Addendum #01

Project Name: Proposed Renovation and Addition: Ellisville City Hall and Police Station

Project Number: 20016

Date: 2023-03-17

ONE-LINE DIAGRAM
SCALE: N.T.S.

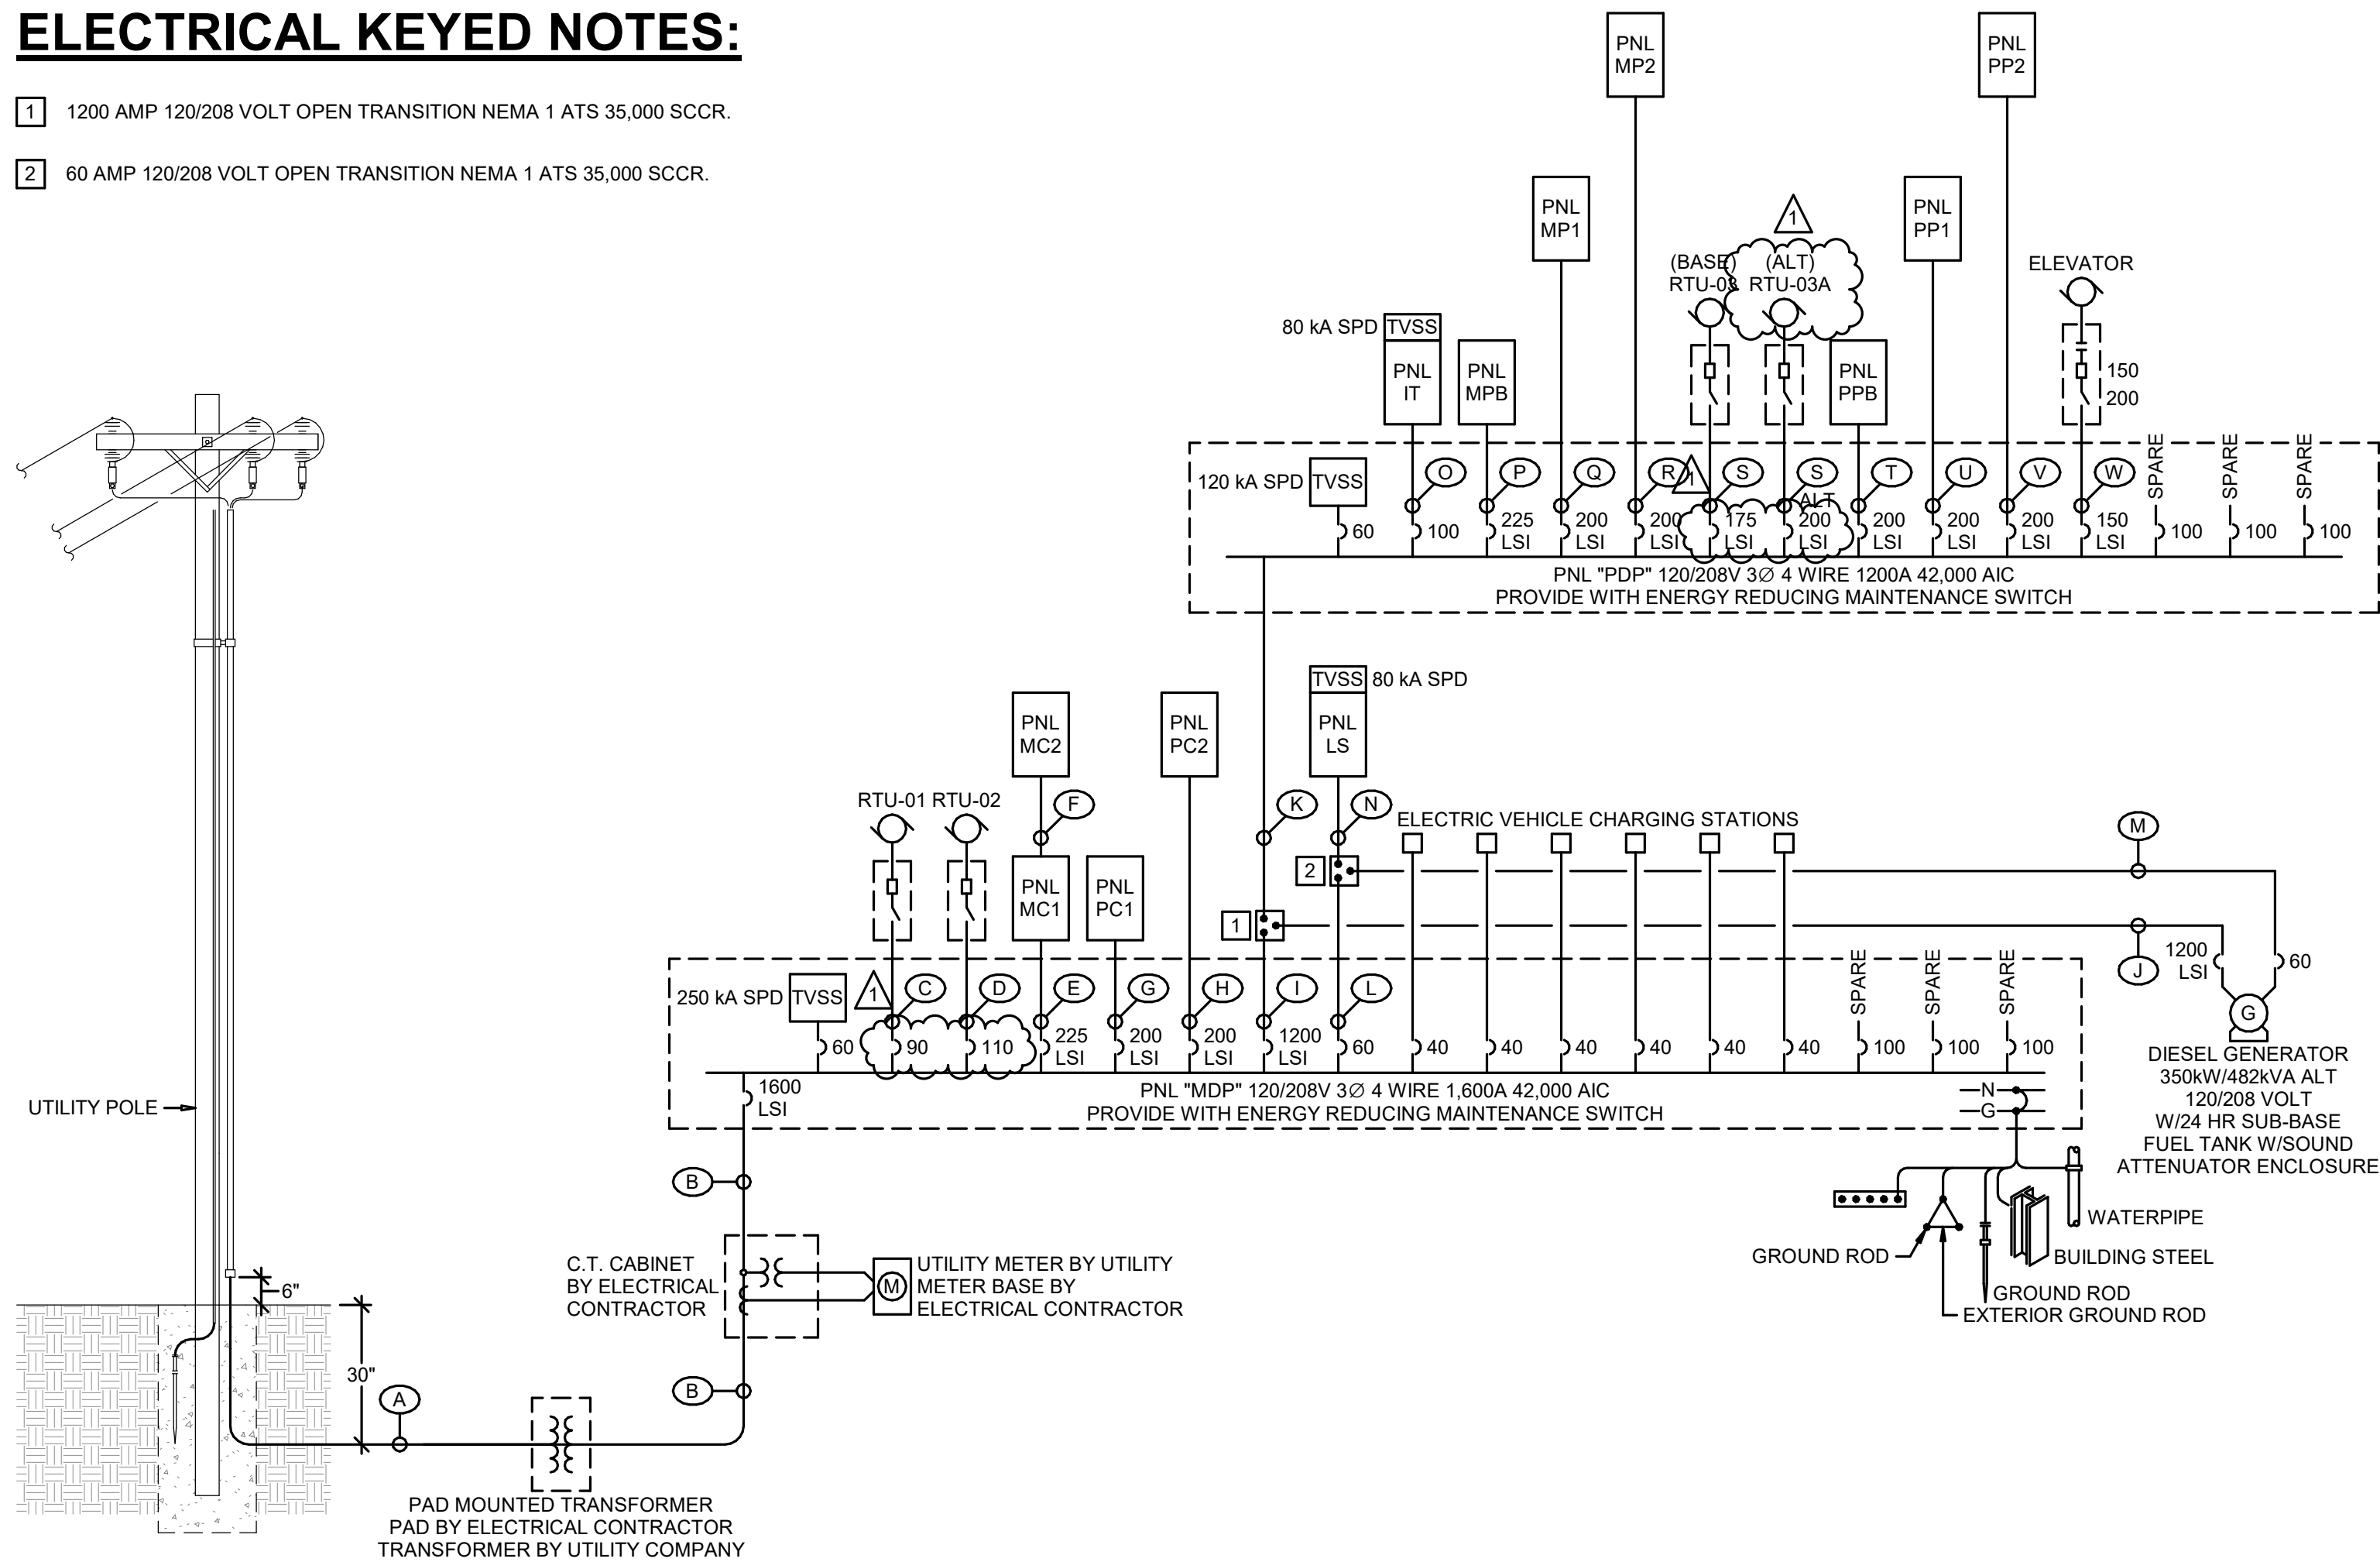
5. Sheet E603: Electrical Schedules and One-Line
 - a. Modified one-line, feeder schedule and equipment data schedule for changes in Rooftop Units.
 - b. Reference attached Revised Sheet.
